Challenges with dSNDR Measurement

Ali Ghiasi - Ghiasi Quantum

IEEE 802.3dj Interim Meeting
New Orleans

May 12, 2025

Figure 179–4—Calculation method for transmitter Δ SNDR

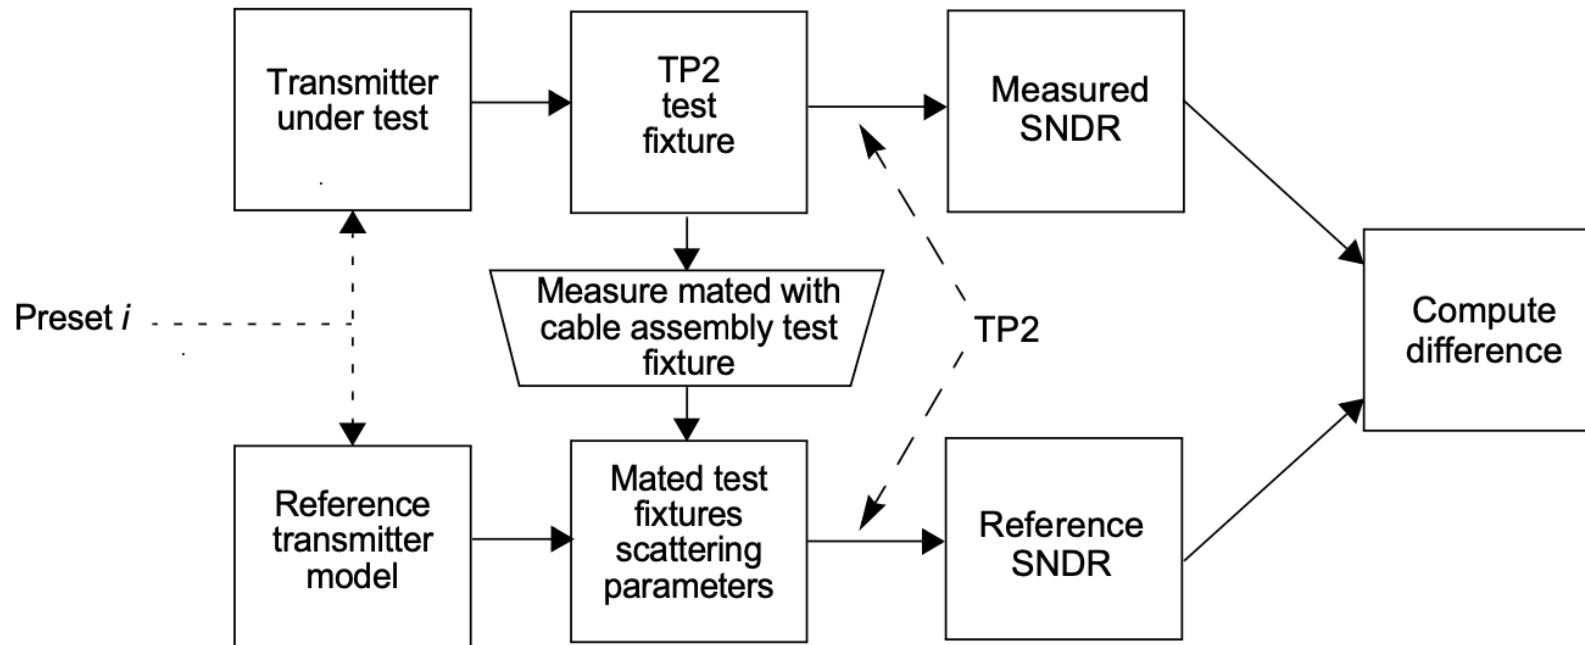
- ❑ SNDR for reference channel is calculated by cascading measured S-parameters with corresponding package
 - dSNDR is the difference between SNDR for reference channel and measured channel.

- dSNDR is calculated for Clause 178 KR defines dSNDR at TP0v
 - Measuring S-Parameters on a test board and performing calculation for two packages and two traces is not overly burdensome
- dSNDR is calculated for Clause 179 CR defines dSNDR at TP2
 - Require measurement of all host channel (512) then cascaded with two packages and two traces is just impractical
- dSNDR is calculated for Clause 176C defines dSNDR at TP0v
 - Measuring S-Parameters on a test board and performing calculation for two packages and two traces is not overly burdensome
- dSNDR is calculated for Clause 176D defines dSNDR at TP1a
 - Require measurement of all host channel (512) then cascaded with two packages and two traces is just impractical.
